NOVI TECH CENTER 6 & 7 JSP17-86

Public hearing at the request of Hillside Investments for Special Land Use, Preliminary Site Plan, Woodland Permit, and Stormwater Management Plan approval. The subject parcel is located in Section 24 east of Seeley Road and north of Grand River Avenue. It is approximately 8 acres and zoned I-1 (Light Industrial). The applicant is proposing to build two 24,861 square foot office/warehouse buildings for a total of 49,722 square feet with associated site improvements.

PLAN REVIEW CENTER REPORT

Review Date: June 11, 2018
Review Type: Preliminary Site Plan
Project Name: Novi Tech Center 6&7
Plan Date: May 15, 2018
Prepared by: Lindsay Bell, Planner
E-mail: lbell@cityofnovi.org **Phone:** 248.347.0484

NFE JOB NO. SHEET NO.
K141 SP-4

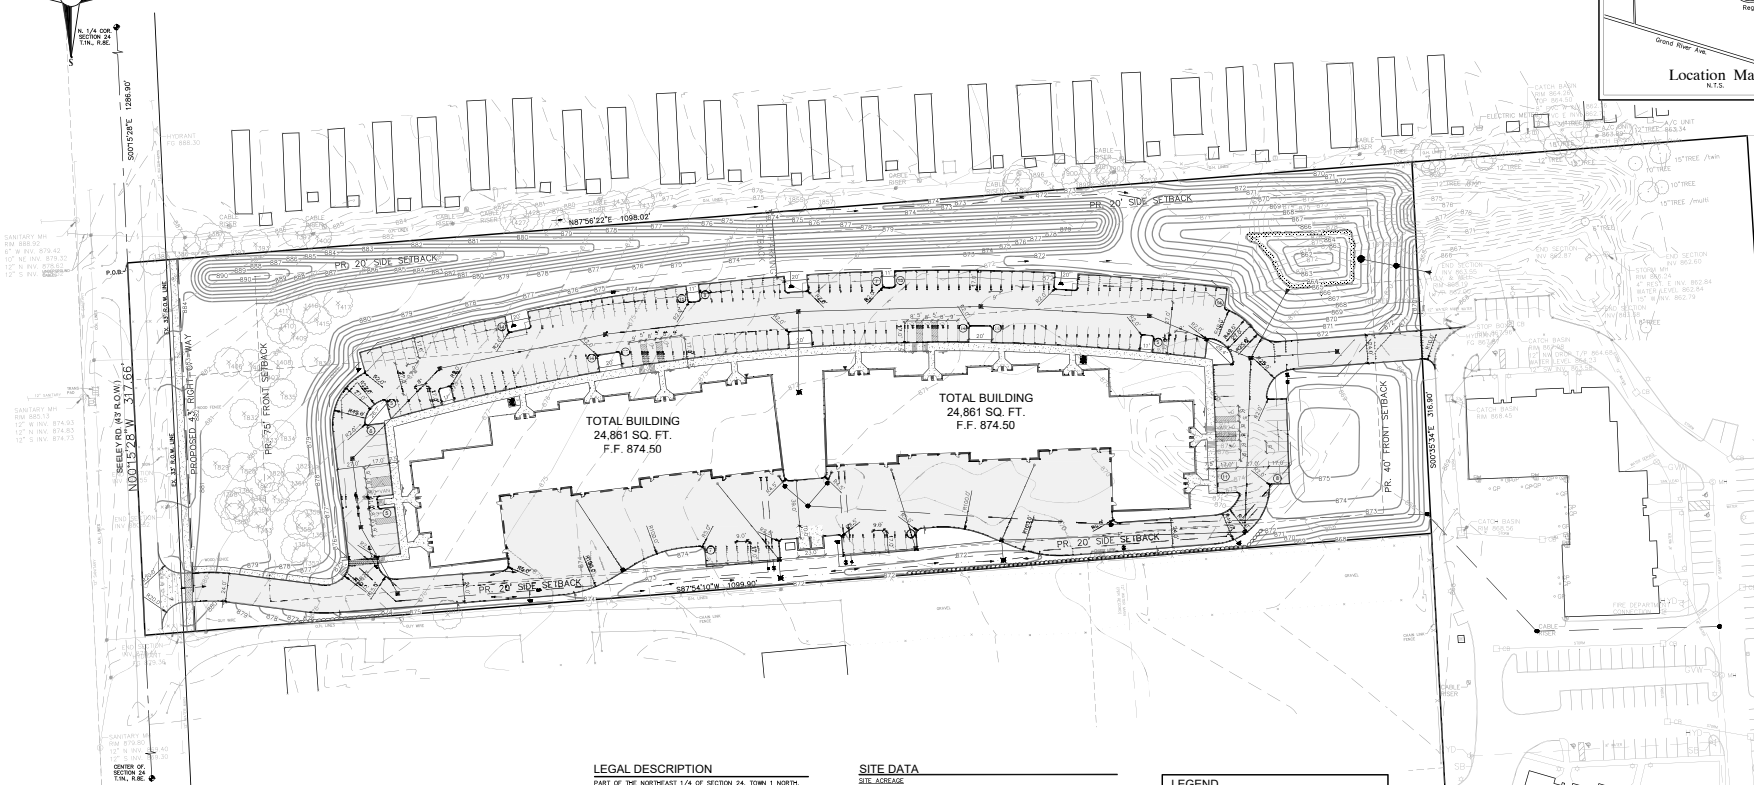
Building Setbacks (Sec 3.1.18.D)				
Front (west)	40 ft.	~189 ft.	Yes	Provide dimensions on plans – closest line of building to lot line
Rear (east)	20 ft.	~196 ft.	Yes	
Side (north)	100 ft. (See 3.6.2.H.b)	~137 ft.	Yes	
Side (south)	20 ft.	~37 ft.	Yes	
Parking Setback (Sec 3.1.18.D) & Refer to applicable notes in Sec 3.6.2				
Front (west)	40 ft. (See 3.6.2.E)	153 ft.	Yes	Provide setback dimensions on plans. Parking on North side does not meet code – ZBA Variance will be requested
Rear (east)	20 ft.	162 ft.	Yes	
Side (north)	100 ft. (See 3.6.2.F.ii)	55 ft.	No	
Side (south)	20 ft.	20 ft.	Yes	
Note To District Standards (Sec 3.6.2)				
Exterior Side Yard Abutting a Street (Sec 3.6.2.C)	All exterior side yards abutting a street shall be provided with a setback equal to front yard.	No side yard abutting street	NA	
Off-Street Parking in Front Yard (Sec 3.6.2.E)	Off-street parking is allowed in front yard if - the site is a minimum 2 acre site, - does not extend into the minimum required front yard setback of the district, - cannot occupy more than	Parking proposed in front yard - Meets (8 acres) - Provided - Provided (less	Yes

Loading Spaces <i>(Sec. 5.4.3)</i>	Loading area in the rear yard, unless abutting residential or interior side yard if adjacent to I, EXPO or EXO district	Entire area south of building interior side yard labeled loading/unloading (22,200 sf)	Yes	
Accessory Structures				
Dumpster <i>(Sec 4.19.2.F)</i>	<ul style="list-style-type: none"> - Located in rear yard - Attached to the building or no closer than 10 ft. from building if not attached - Not located in parking setback - If no setback, then it cannot be any closer than 10 ft, from property line. - Away from Barrier free Spaces 	Dumpster shown in proper location on southern edge of parcel, outside of parking setback	Yes	Label rectangle shape on the west side of the dumpster enclosure – unclear what it is

Transformer/ Generator	Provide location of any proposed transformers/ generators etc.	No transformers or generators shown	No	Accessory structures to be located in the rear yard and screened with landscaping – identify any on site plan
I-1 District Required Conditions (Sec 3.14)				
Outdoor Storage of above ground storage tanks (Sec. 3.14.1.B.ii)	Outdoor placement of above-ground storage tanks of not more than 600 capacity per tank and accessory to an otherwise permitted use. Additional conditions apply.	Not Proposed	NA	
Outdoor Storage of recreational equipment (Sec. 3.14.1.B.iii)		Not Proposed	NA	
Other (Sec 3.14.2)	Unless otherwise provided, dealing directly with consumer at retail, is prohibited.	Noted on sheet SP-4	Yes	
Adjacent to Freeway ROW (Sec 3.14.4)	Where a permitted use abuts a freeway right-of way , special conditions listed in section 3.14.4 apply	Not adjacent to Freeway ROW	NA	
Adjacent to Residential District - Special Conditions (Sec 3.14.5)

Bicycle Parking Lot layout <i>(Sec 5.16.6)</i>	<p>Parking space width: 6 ft.</p> <p>One tier width: 10 ft.</p> <p>Two tier width: 16 ft.</p> <p>Maneuvering lane width: 4 ft.</p> <p>Parking space depth: 2 ft. single, 2 ½ ft. double</p>	Bicycle parking layout is shown sheet SP-4	Yes	
Loading Spaces <i>(Sec. 5.4.3)</i>	Loading area in the rear yard, unless abutting residential or interior side yard if adjacent to I, EXPO or EXO district	Entire area south of building interior side yard labeled loading/unloading (22,200 sf)	Yes	
Accessory Structures				
Dumpster <i>(Sec 4.19.2.F)</i>	<ul style="list-style-type: none"> - Located in rear yard - Attached to the building or no closer than 10 ft. from building if not attached - Not located in parking setback - If no setback, then it cannot be any closer than 10 ft. from property line. - Away from Barrier free Spaces 	Dumpster shown in proper location on southern edge of parcel, outside of parking setback	Yes	Label rectangle shape on the west side of the dumpster enclosure – unclear what it is Will label as Transformer Pad

Figure 1. City of Novi Regulated Wetland & Woodland Map (approximate property boundary shown in red). Regulated Woodland areas are shown in green and regulated Wetland areas are shown in blue.

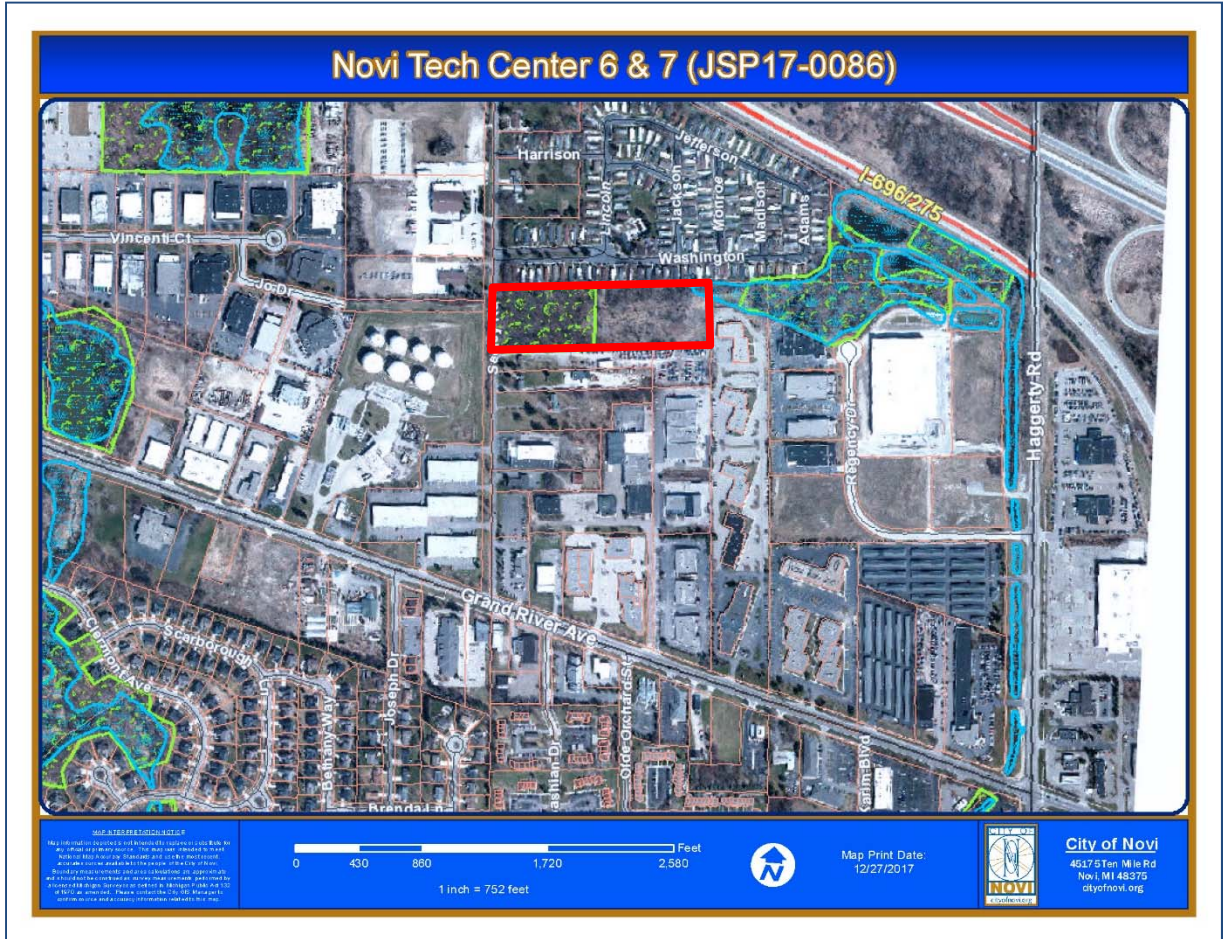
Based on our review of the Plan, Novi aerial photos, Novi GIS, City of Novi Official Wetlands and Woodlands Map (see Figure 1), and on-site evaluation this proposed project site contains areas indicated as Regulated Woodlands as well as Regulated Wetlands. The area of regulated woodland encompasses approximately the western half of the site.
